RE: CBA 1174-E, Holton Arms

Subject: CBA 1174-E, Holton Arms

Please see the comments/questions (below) on the information submitted on March 3, 2026. If the are redundant, I apologize in advance, but a lot of information was on different plans, as noted.

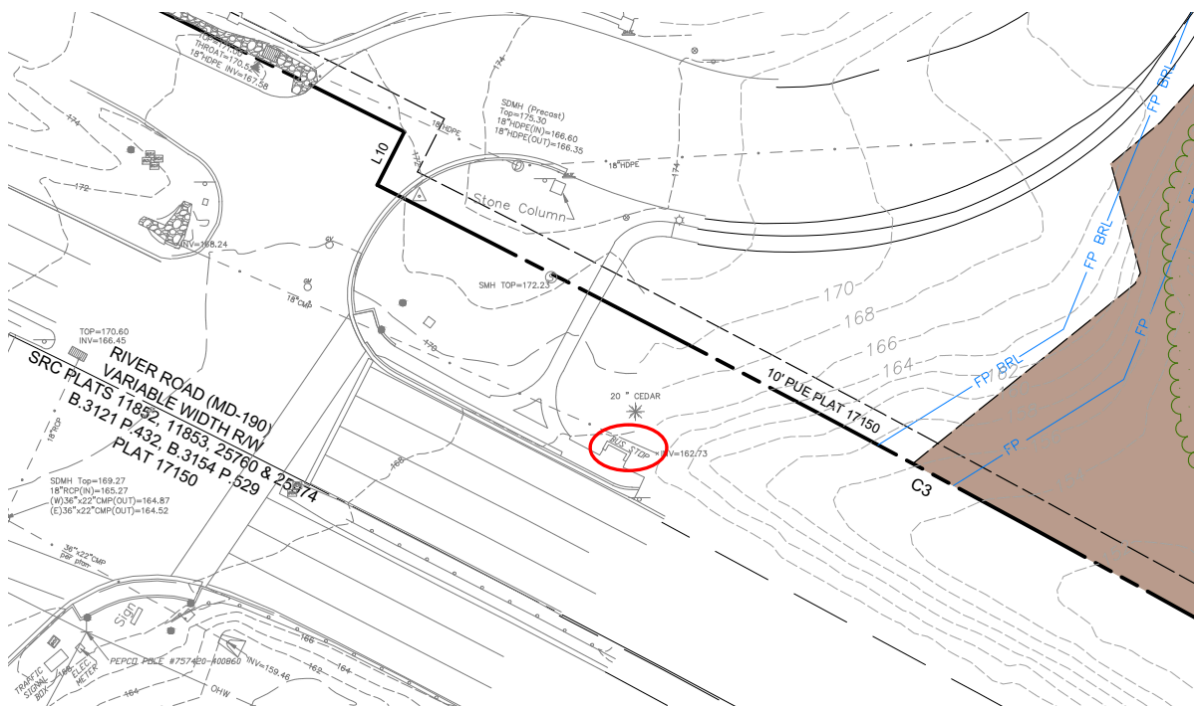
- Exhibits #85(f) through 85(f) do not show existing landscaping, including width, vegetation type, numbers, location of fencing, walls submitted, Exhibits# 85(a) through #85(f) show only existing tree canopy. While existing landscaping is grandfathered, the Land Use Report still relies on vegetative buffering for compatibility.

This question will be addressed by Mr. La Vay's testimony which will cover site orientation of existing landscaping, including width/depth, vegetation type, location of any fencing/walls, etc.

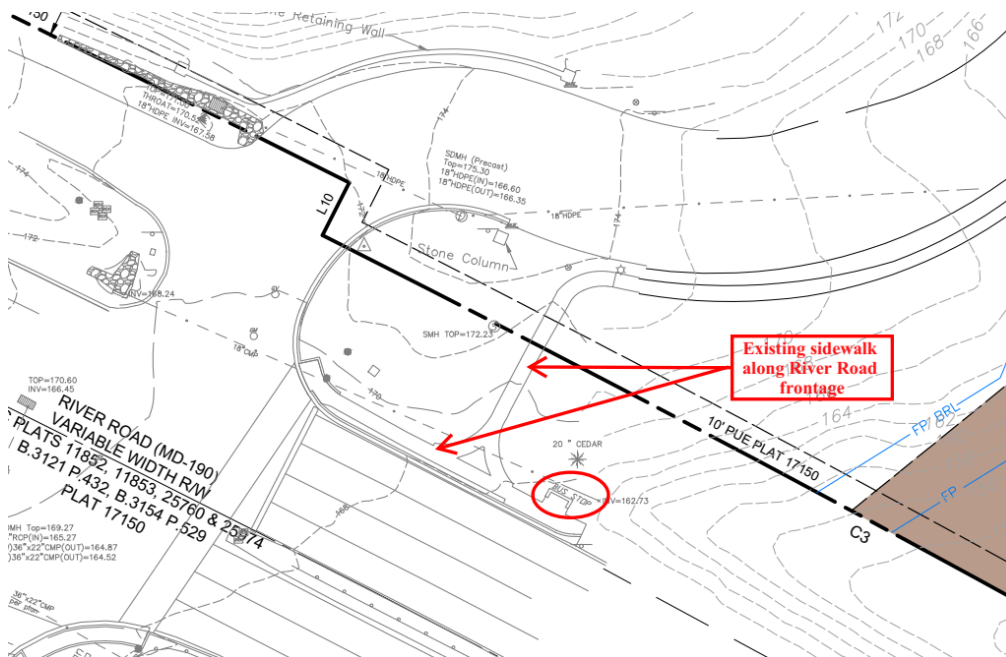
- No existing lighting shown on buildings, in existing parking lots, along the site entrances, per Section 59-G.1.23.(h) of the Montgomery County Zoning Ordinance, 2004. Even though existing lighting is grandfathered, it would be helpful to understand what lighting will occur during the off-peak, including early morning and evening activities.

This question will be addressed by Mr. La Vay's testimony which will cover site orientation of all existing improvements, inclusive of lighting. There are existing security lights in the parking lots and around the building, but no lighting on any of the play fields or tennis courts.

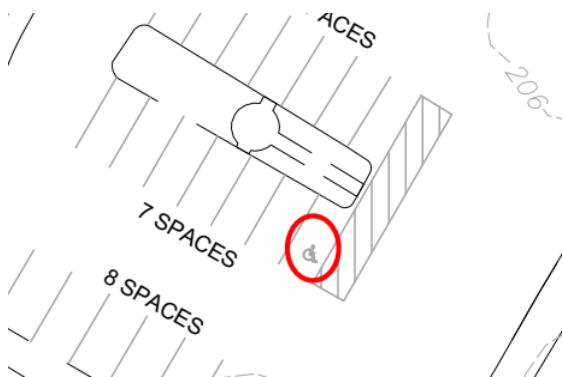
- Existing parking spaces are shown on Gorove Slade Exhibits #84 and #84(a) but specific location of ADA spaces is not shown only noted in each area of parking. Exhibit#85(a), the Development Standards Table does not show number ADA parking spaces.

All ADA spaces are marked on the site plan sheets with HC symbol – total number of HC spaces on site can be added to the Development Standards Table.
